AGENDA PORTLAND PLANNING BOARD MEETING

Memorandum Planning and Urban Development Department

To: Brandon Mazer, Chair and Members of the Portland Planning Board
From: Andrew Tufts, Planner
Date: February 5, 2021
Re: 100 BLDG F West Commercial Street (Canal Landing Phase V)
Project #: PL-001220-2020
Meeting: February 9, 2021
CBL: o6o Foo3

Subject: Canal Landing New Yard – Phase V (Building F)
100 West Commercial Street
Level III Preliminary Site Plan Application
Applicant: New Yard, LLC

2B CONSTRUCTION

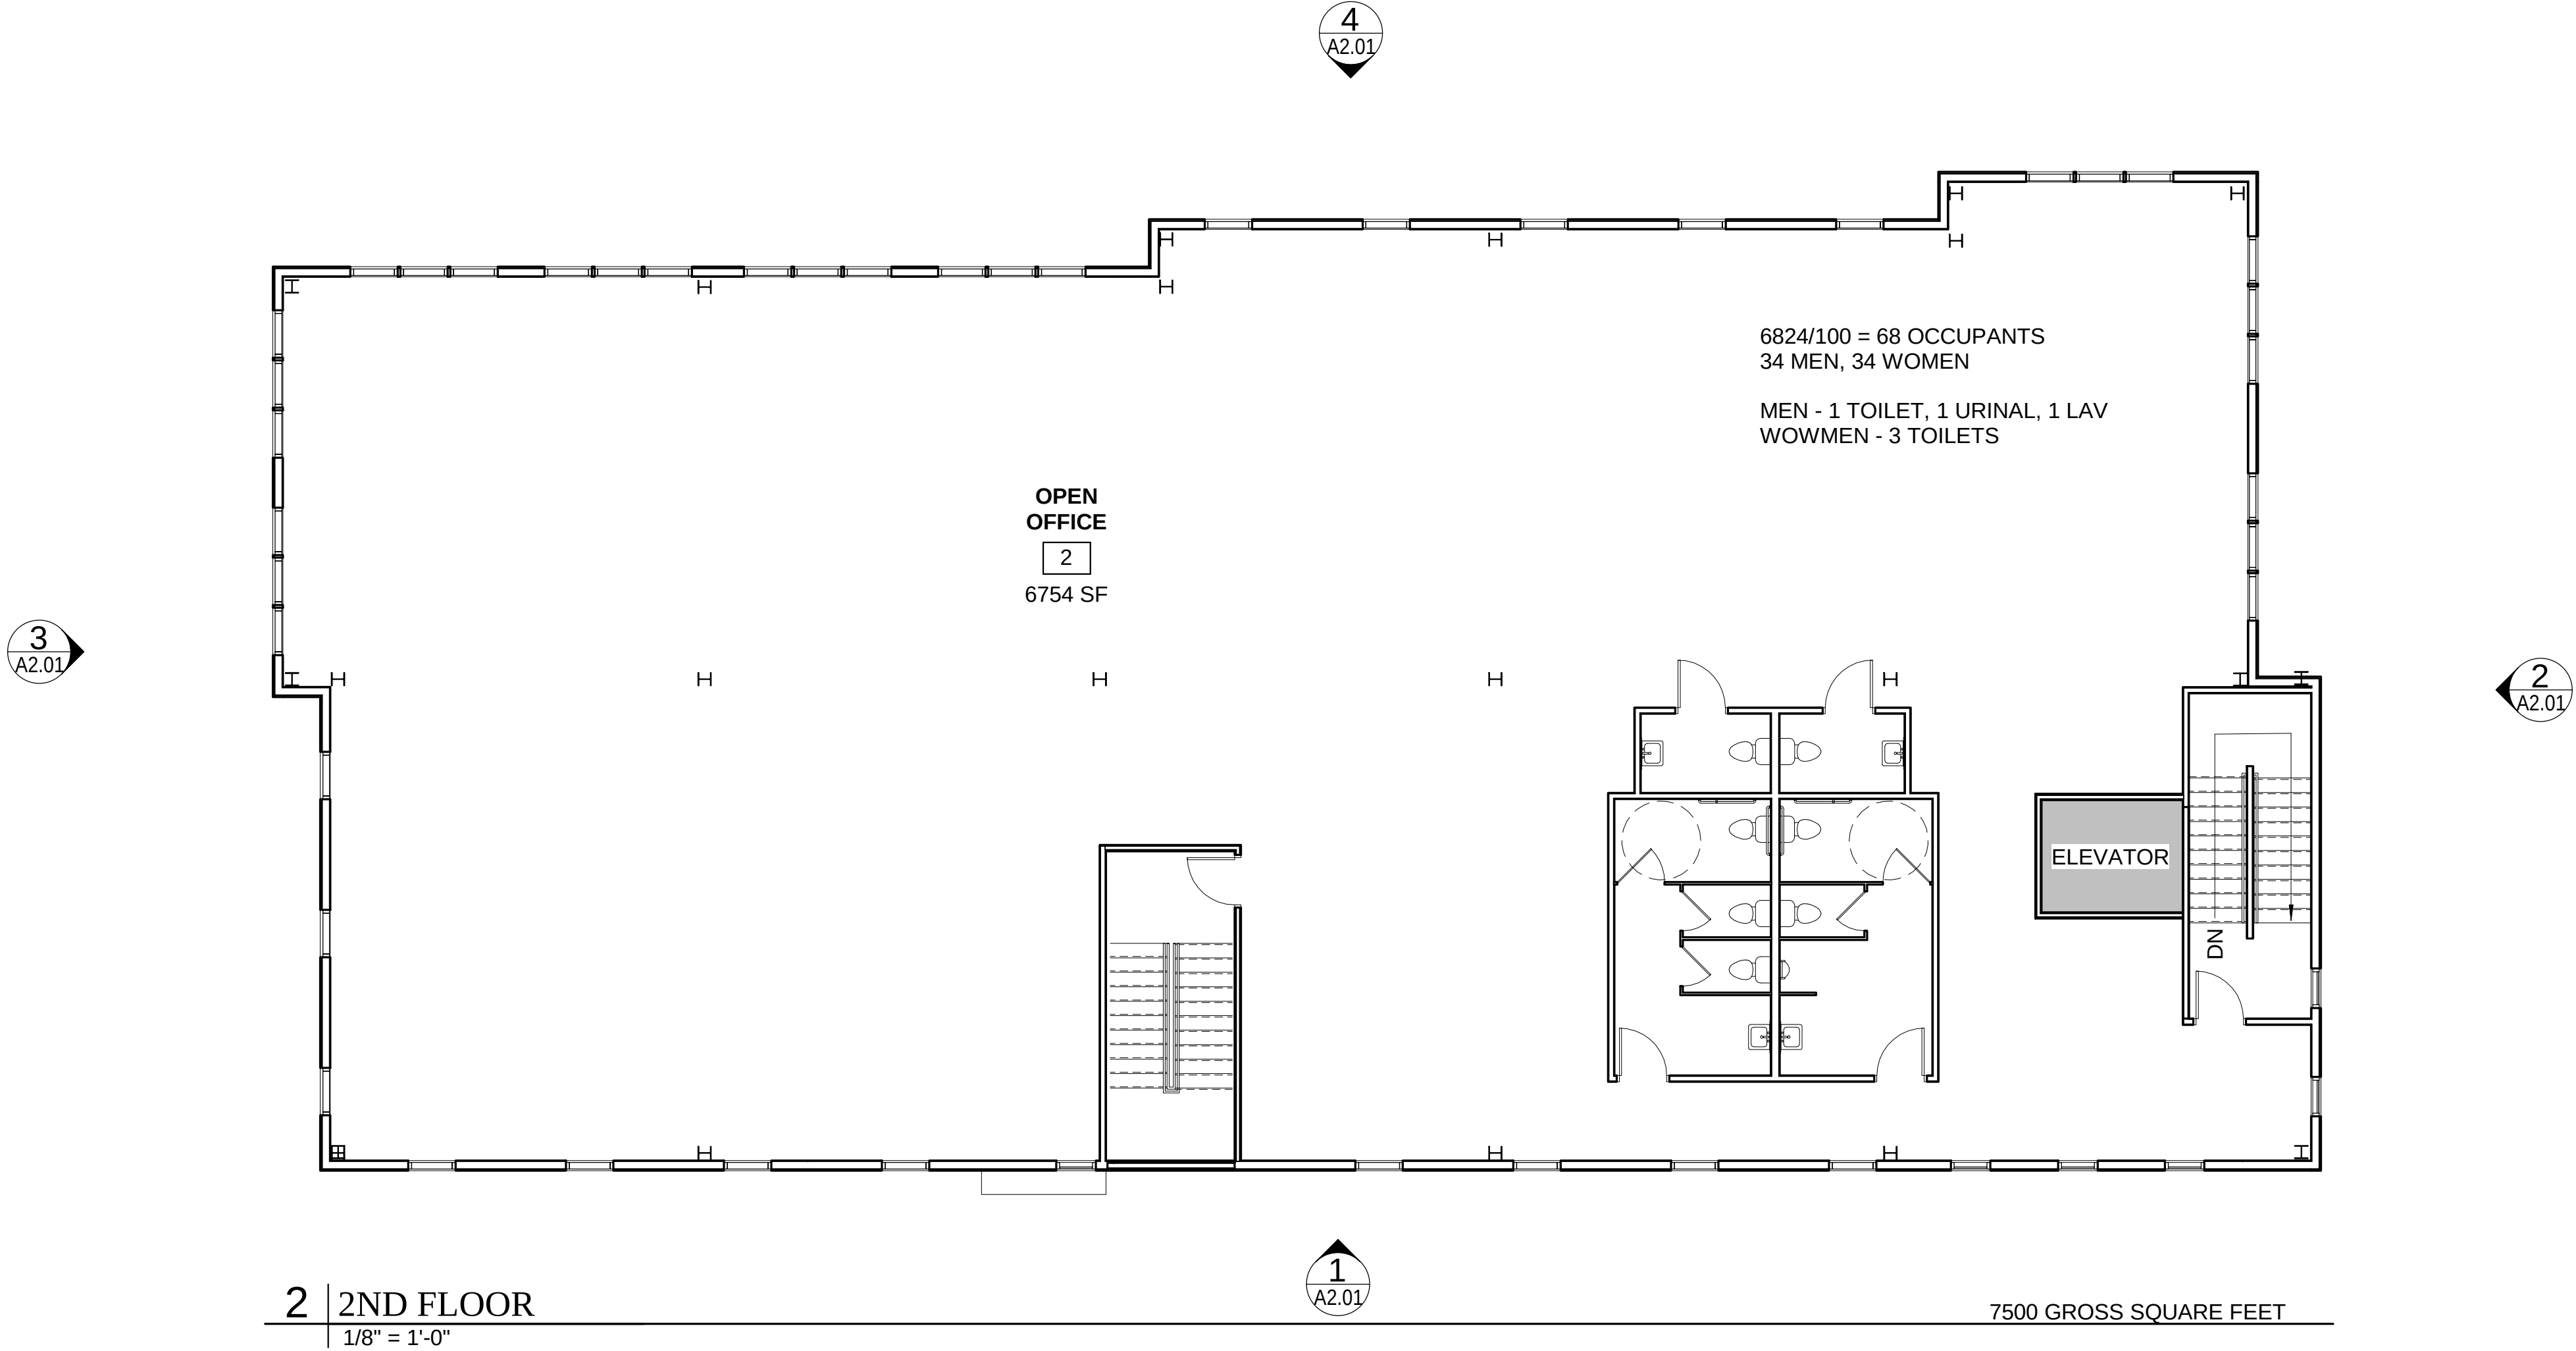
- 4. The basement plan, sheet A1.00 divides the space up into 3 tenants. The use is labeled office, industrial. Office is not a permitted use in the zone and industrial is pretty vague. Can you ask them if they have specific tenants in mind?*

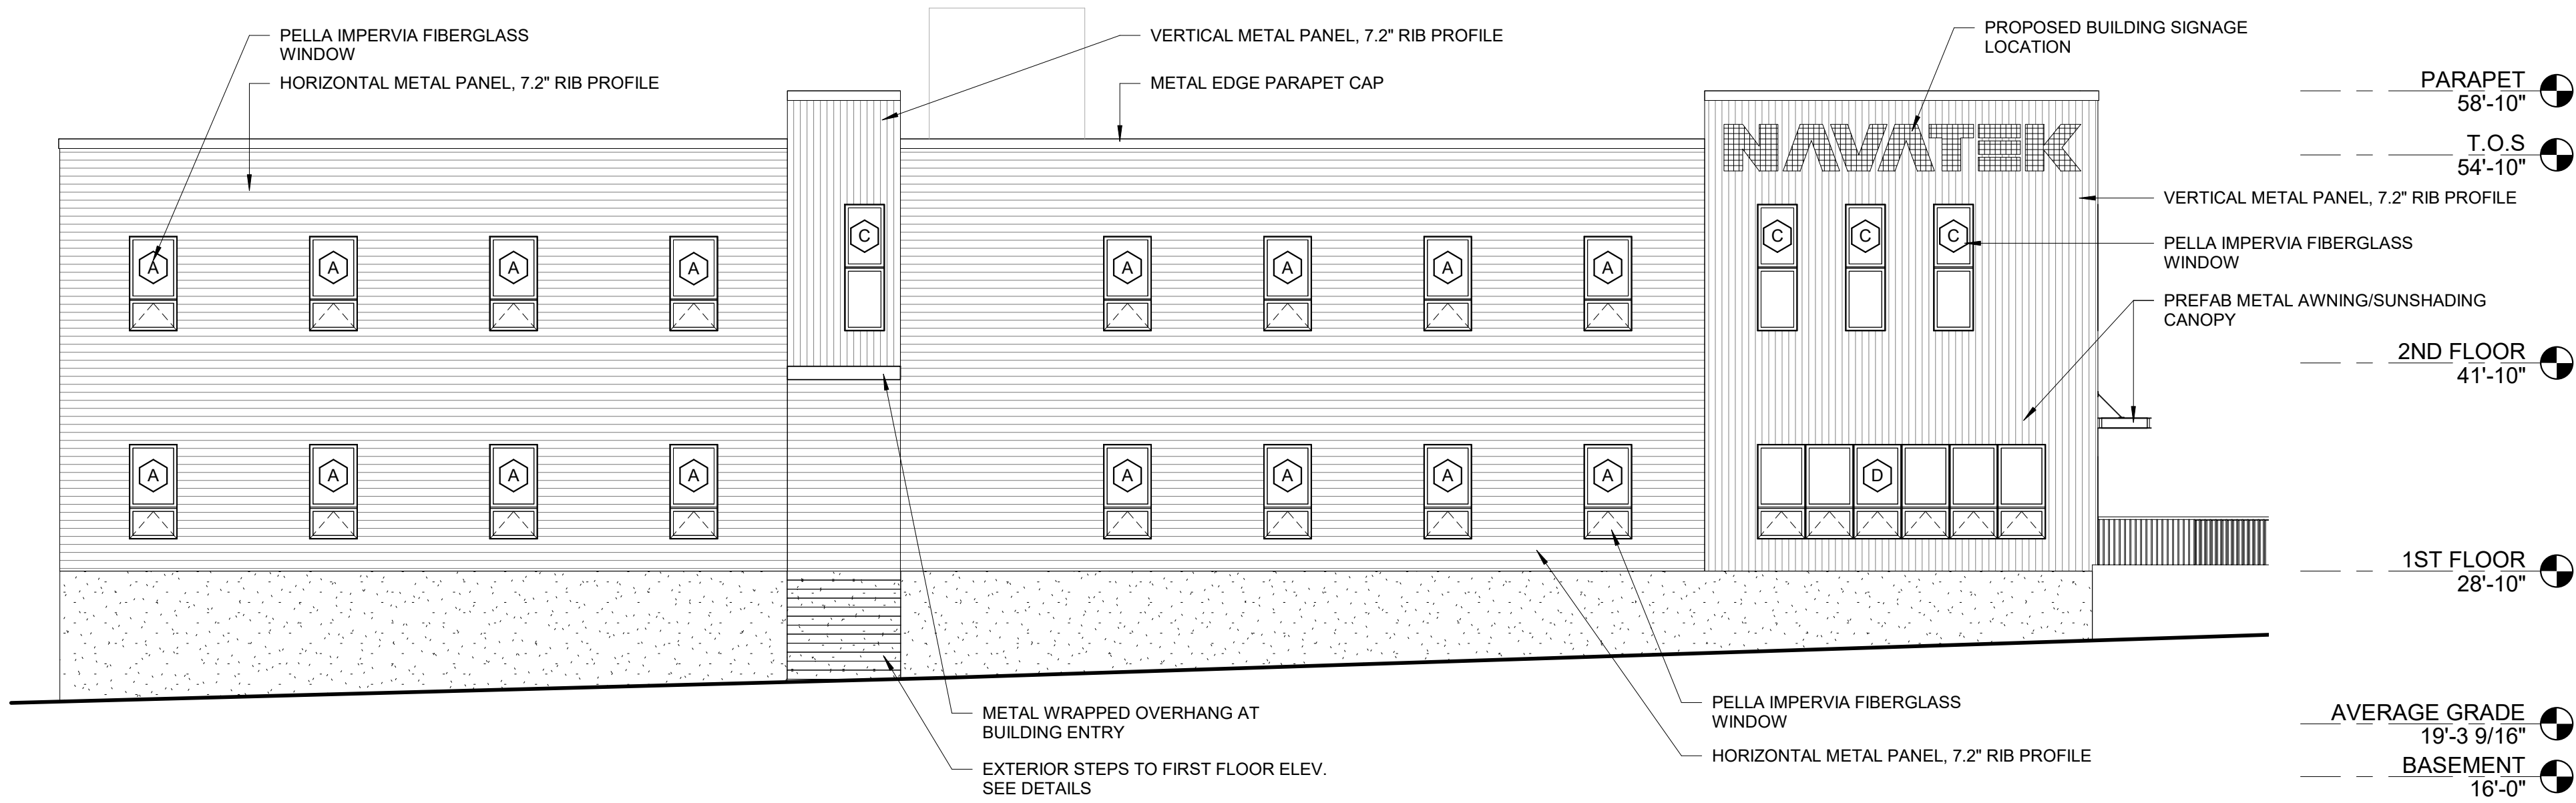
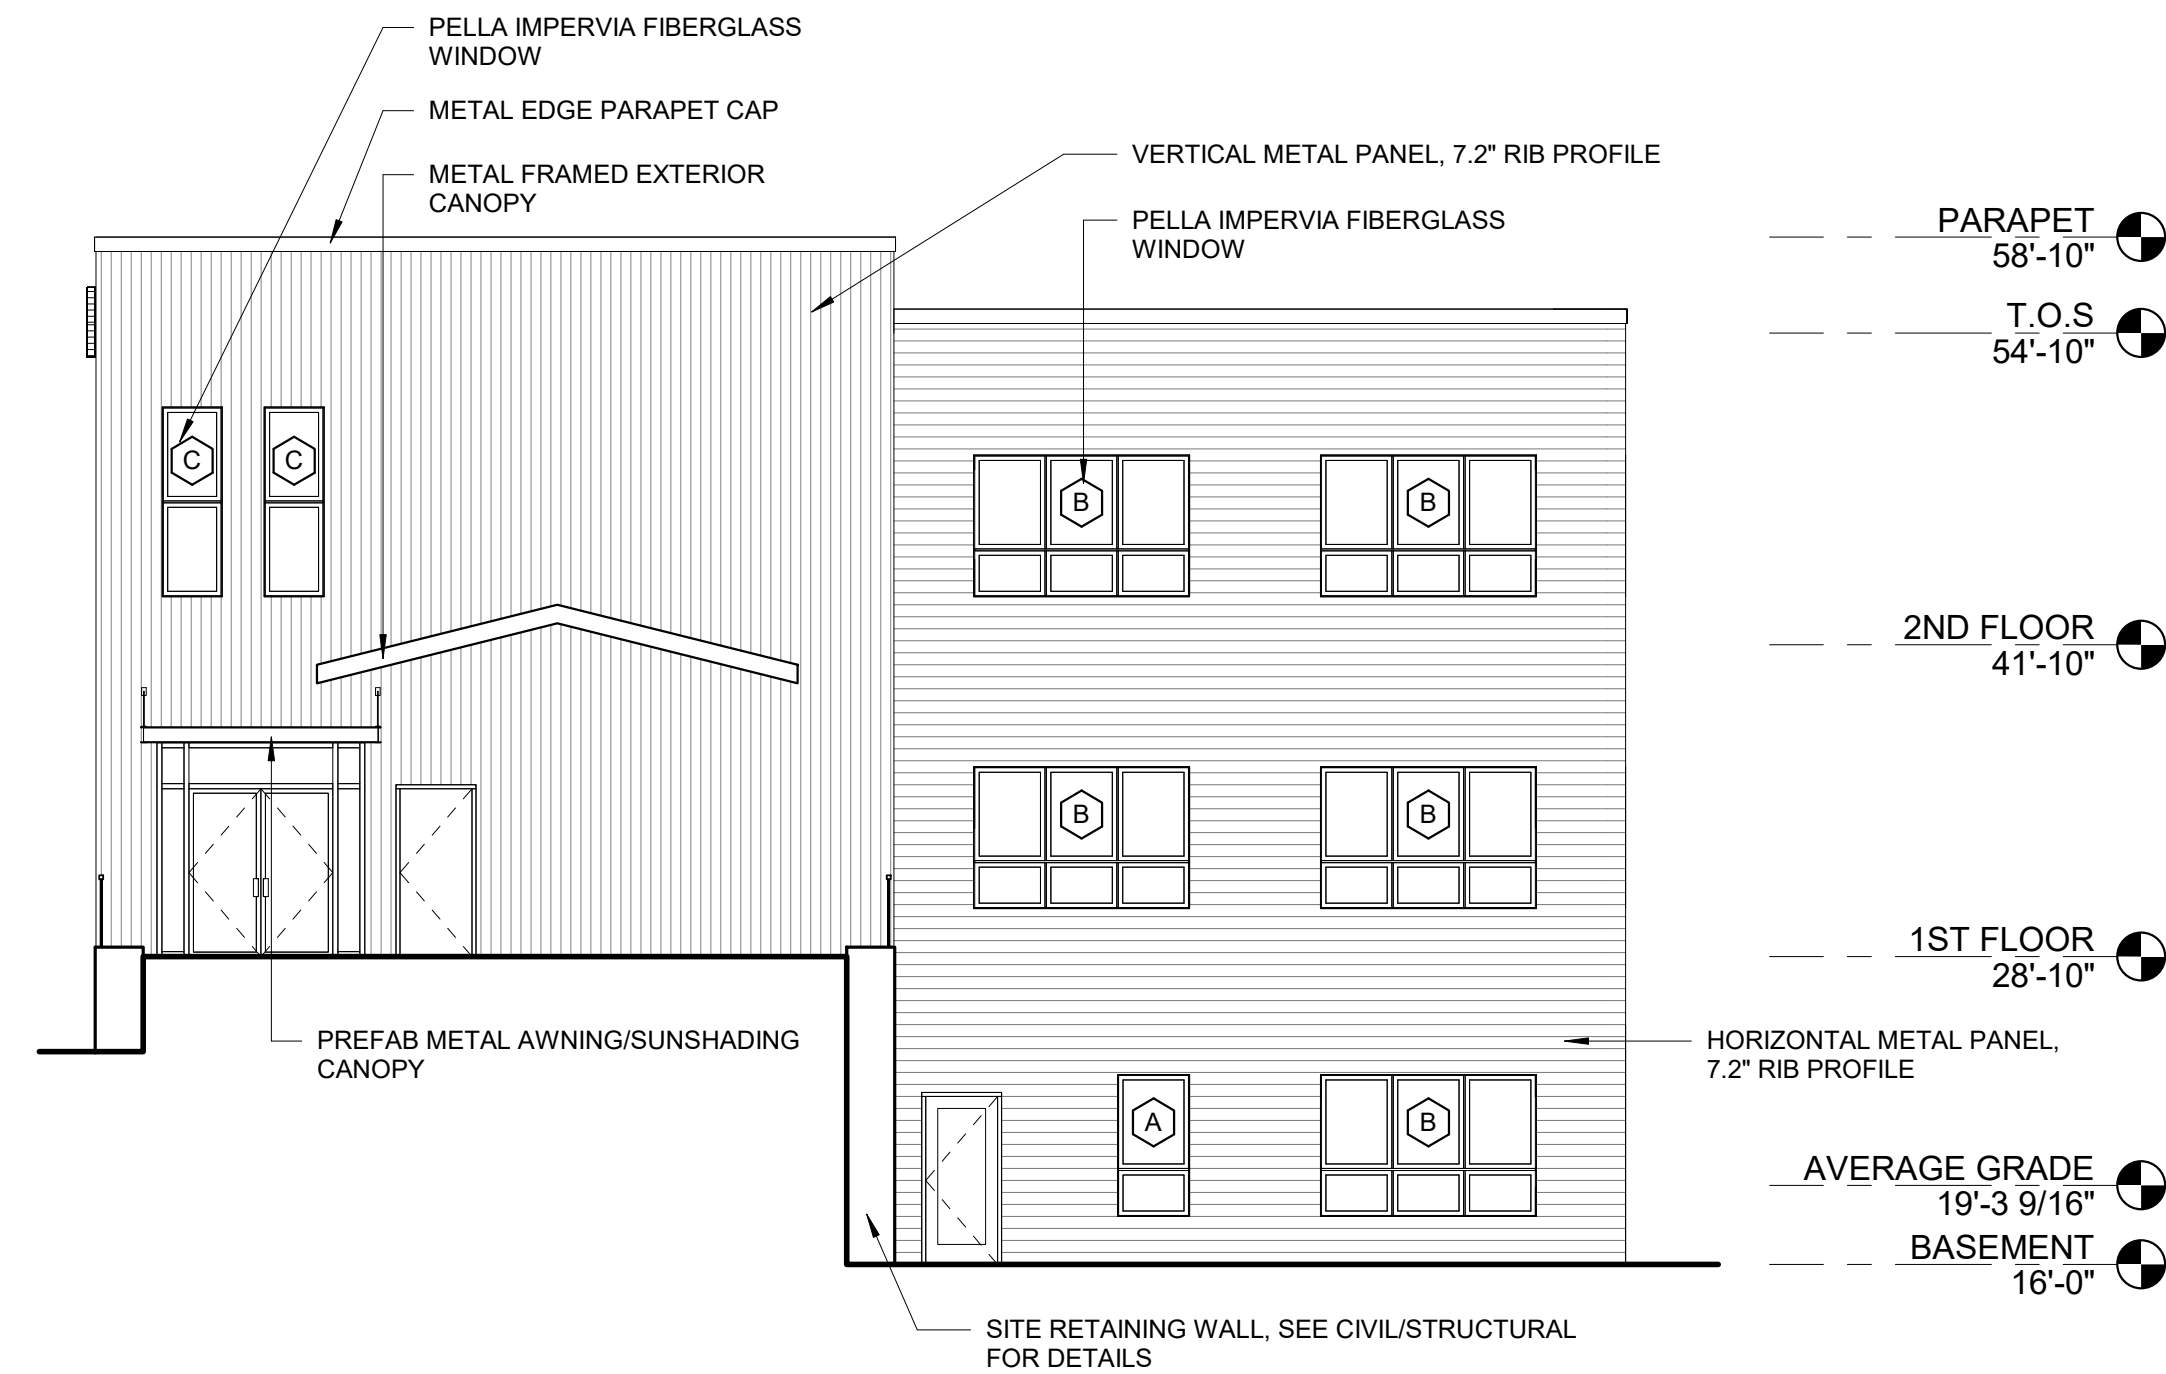
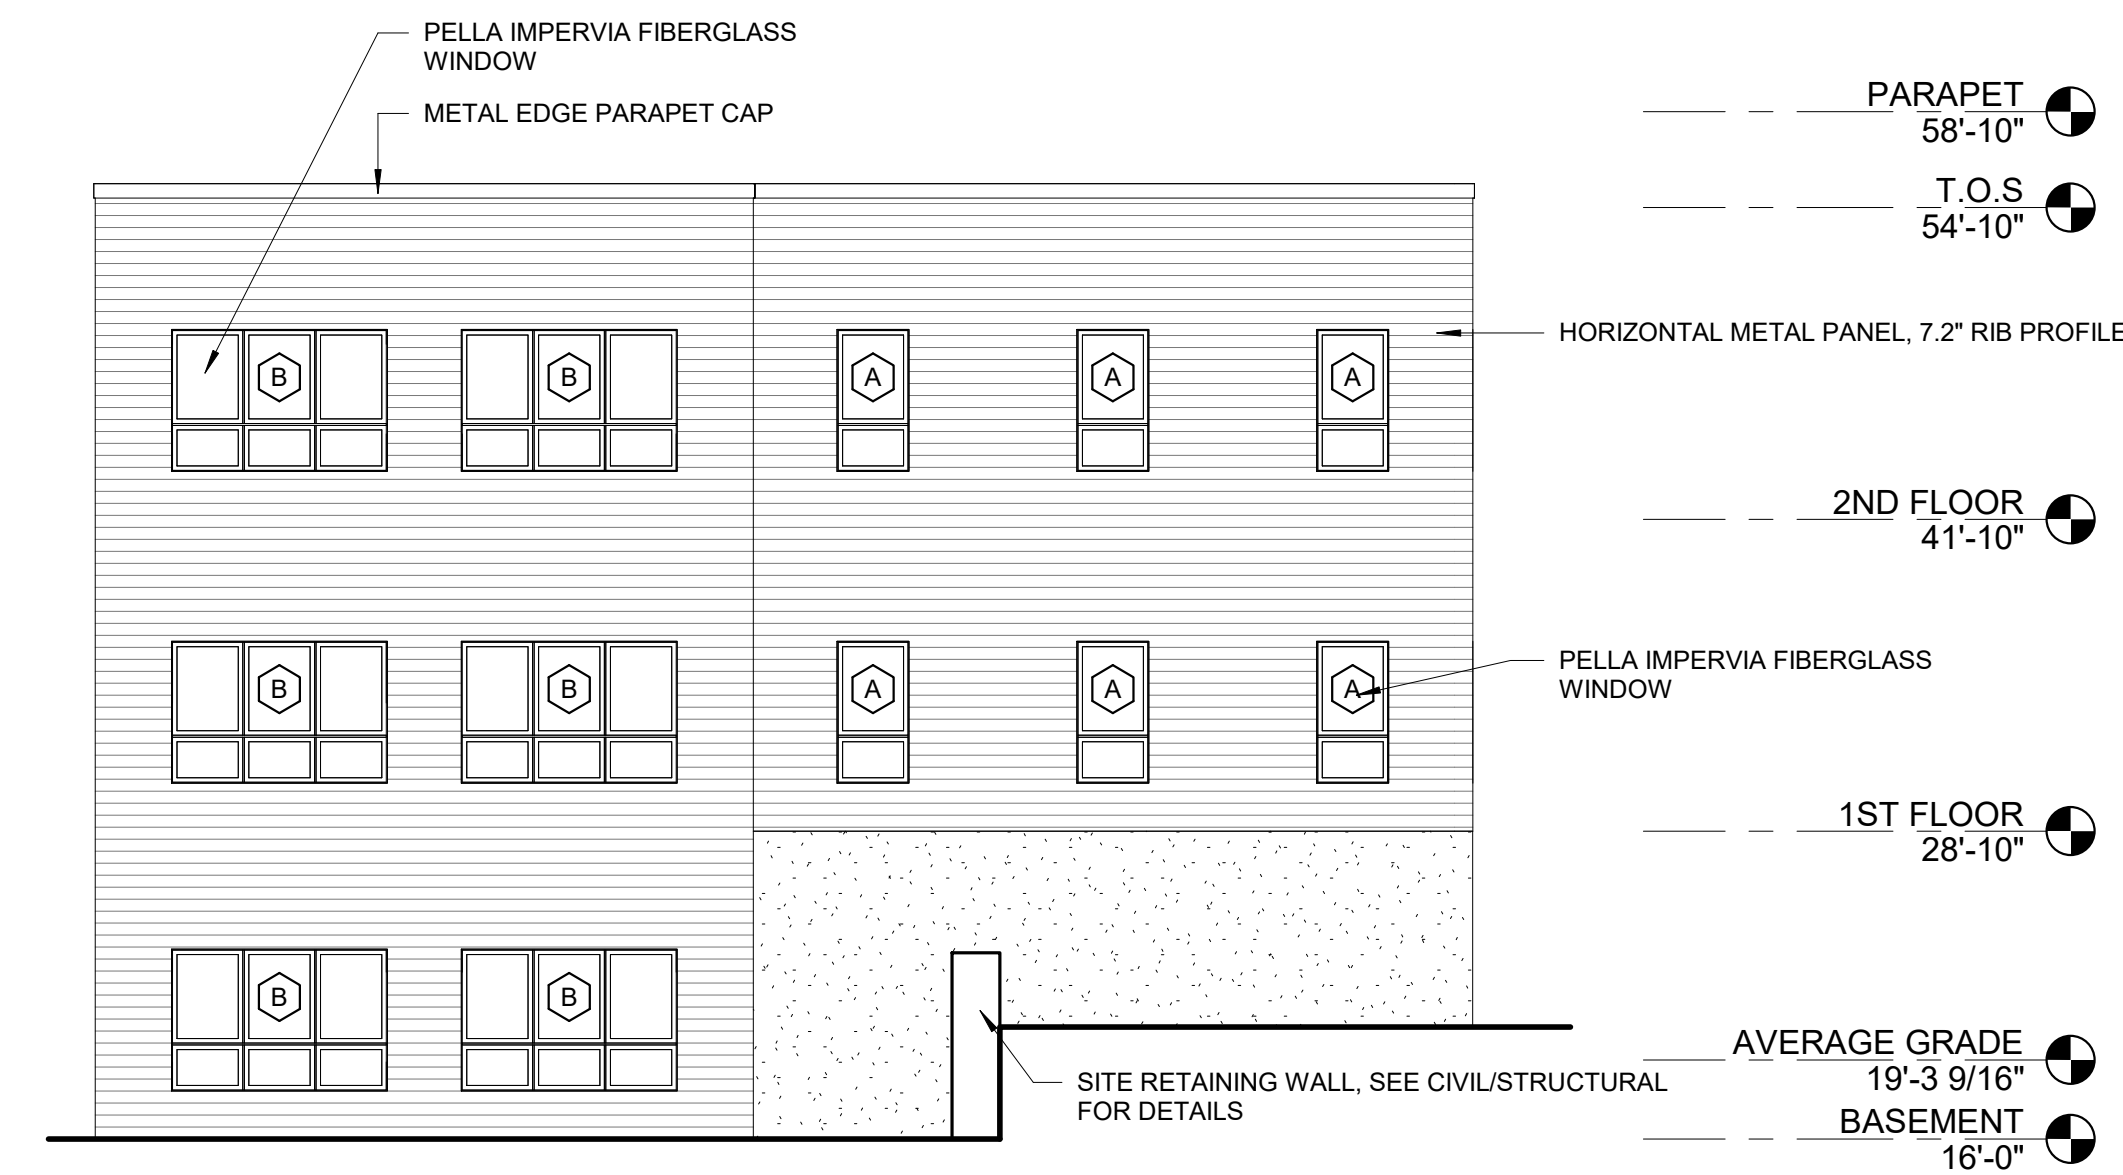
- 3. The average grade of 19.295' provided on Plan A1.00, needs to be shown on the elevation plan, A2.01.*

Response: A revised Plan A2.01 has been prepared and uploaded to ePlan and a copy also accompanies this letter.
